Glen Canyon NRA

Glen Canyon NRA Response to USBR -12-mile Slough Modification Proposal

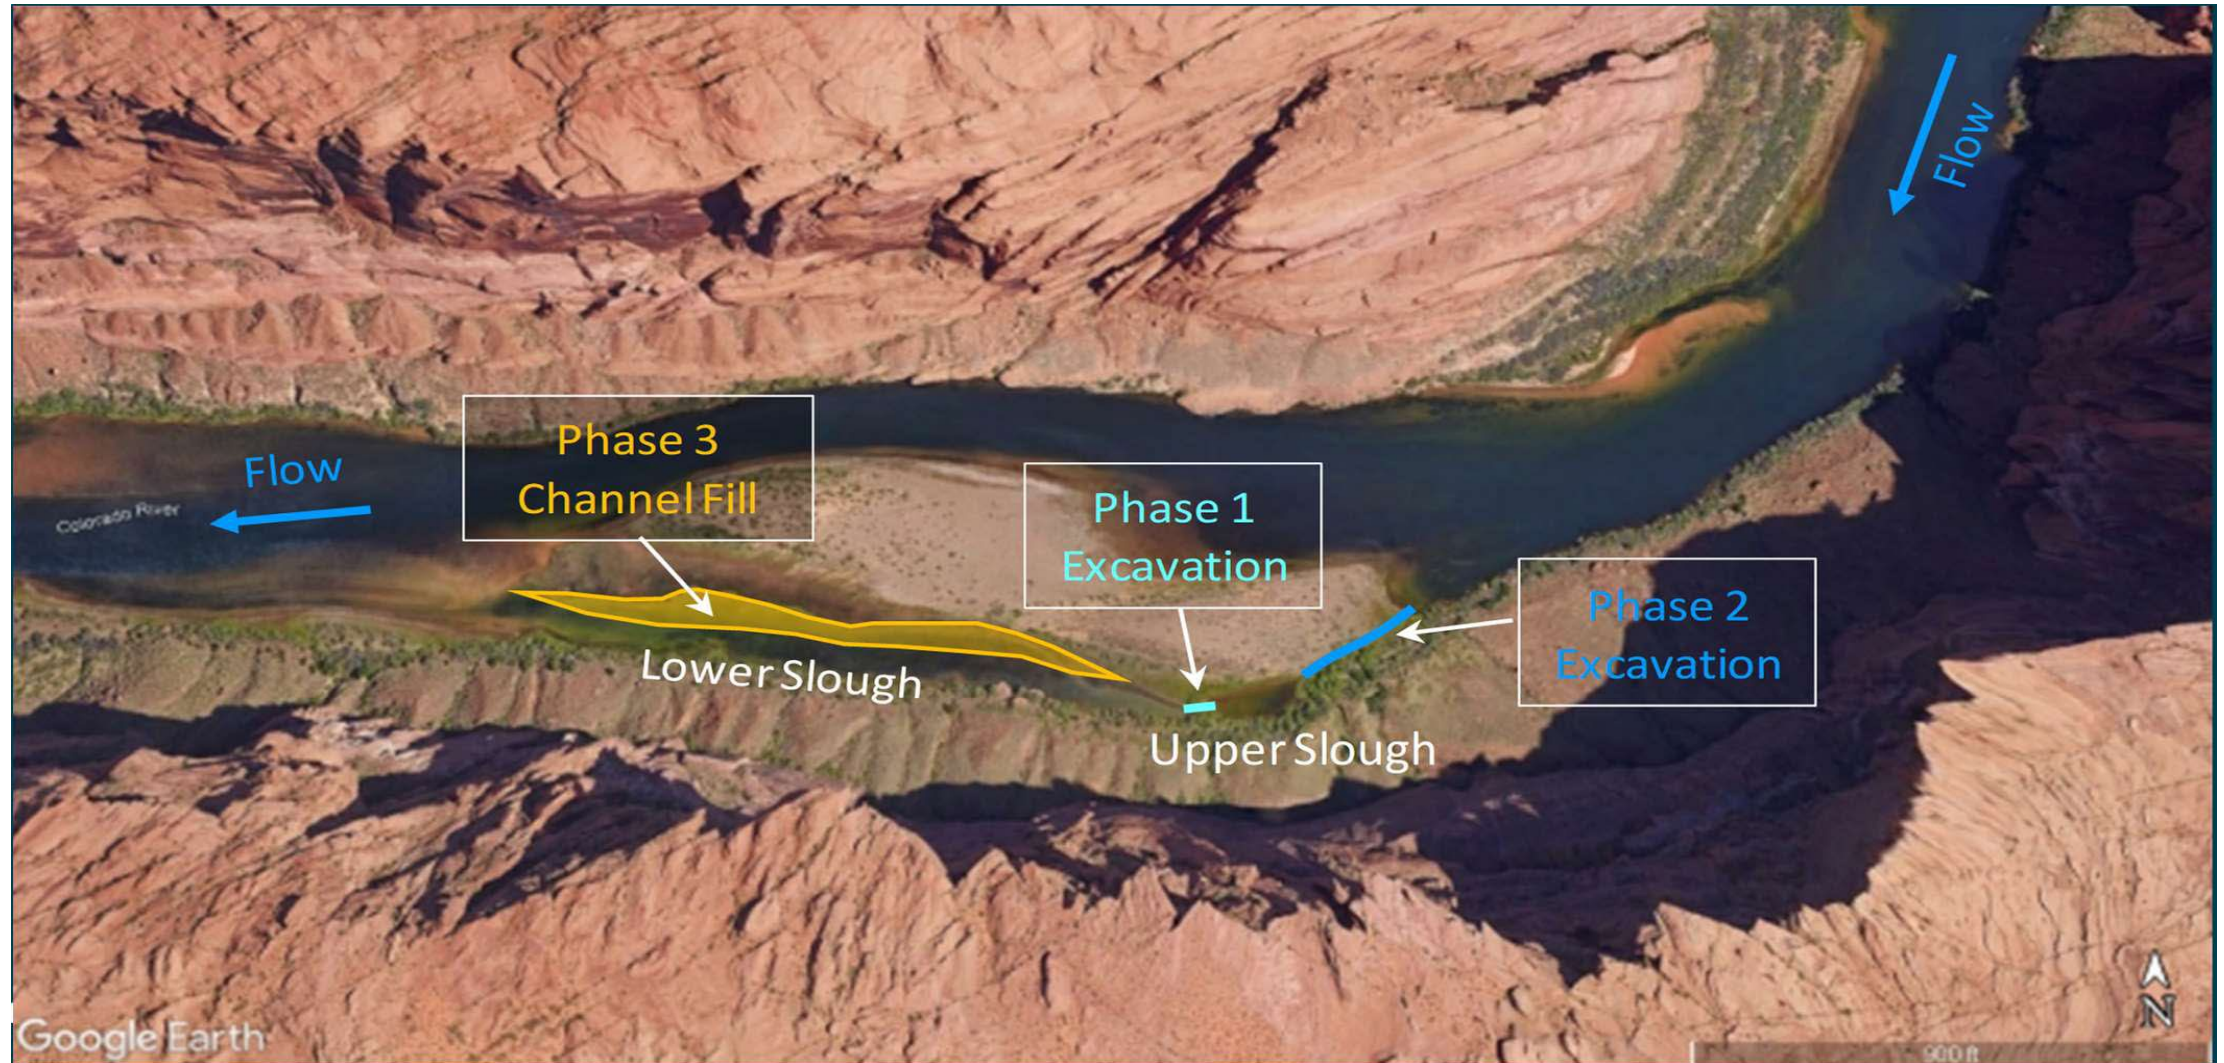
Thoughts on Reclamation's -12-mile Slough Proposal

- Cut between upper and lower sloughs – more than hand shoveling
- Significant elevation change from river bend to upper slough
- Cut from river bend to upper slough longer and deeper
- Armoring of inlet from river bend to upper slough?
- Large amount of fill to narrow lower slough. Permit? Mitigation?
- Initial or final restoration – native plants, select fauna, hydrology.
- NEPA and other compliance – use prior documents?
- Can we identify additional alternatives? (Low water? Pipes? Weirs?)
- Work will require helicopter time, heavy equipment, and maintenance to be effective
